**CONCRETE BATCHING PLANT  
AIR GENERAL PERMIT REGISTRATION FORM**

**0830051-004**

**From:** Dibble, Dickson  
**Sent:** Tuesday, April 05, 2011 5:14 PM  
**To:** 'blessed646@aol.com'  
**Cc:** Ajhar, Rebecca  
**Subject:** RE: Concrete Batching Plant Air General Permit Registration Form, Facility ID# 0830051;Seiler'sConcrete,SilverSpgsPlant

**Subject:** Processed AIRS ID# 0830051-004, SEILERS CONCRETE dba SEILERS CONCRETE, 13384 NE 1ST STREET RD, SILVER SPRINGS, FL 34488-3703  
**Location:** CONCRETE BATCHING PLANT-Silver Springs  
**Start:** Tue 3/15/2011 12:00 AM  
**End:** Wed 3/16/2011 12:00 AM  
**Show Time As:** Free  
**Recurrence:** (none)  
**Organizer:** Dibble, Dickson  
**Categories:** PENDING

- Belle style Dust House
- Dust filter on silo

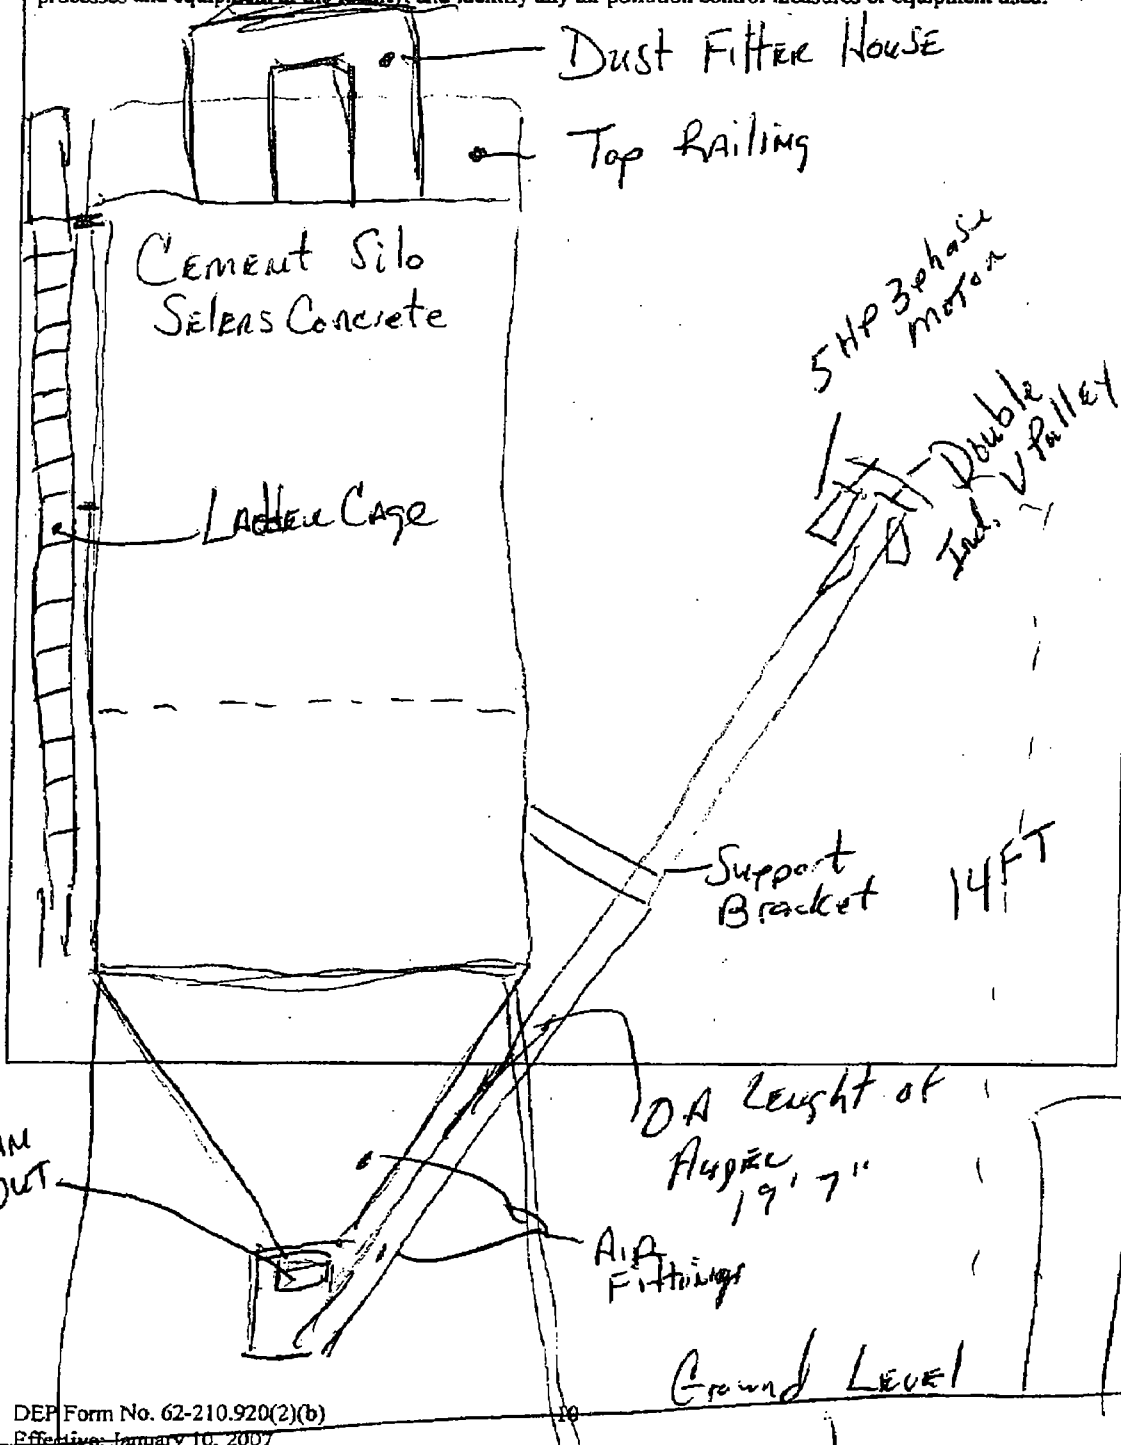
I received your FAX containing the hand-drawn layout of your facility including the pictures. Unfortunately the pictures did not do well coming through as a FAX. The problem is that I am unable to enter pictures or drawings into our database.

Since you have identified the silo as your cement silo please provide me with the **Make** of the silo, **Model** of the silo, or at least the **capacity of the silo in Bbls or Cu. Yds.** Is it a Belgrade?

It's hard to tell, but I think from your drawing you indicated that you have a ground mounted "Belle Style Dust House", but **what emission point does it serve and what is the model of the Belle Style dust house?**

**What is the make and model of your dust filter house shown on top of your cement silo?**

Mr. Dibble, In searching records in file cabinet, I found that the Brown equipment company is the maker of the silo and the capacity is 350 barrel [1400 cu. ft.] 8' 6" tall [10,000 empty weight portable silo]. The model / part# to the dust collector on top is # 514429 -National Filter. The model / part # to the dust house on the ground is 514552- National Filter. The purpose of the dust house on the ground is to collect dust when loading the truck. I believe this is the information you ask me to find. Thank you for your help. Have a God blessed day
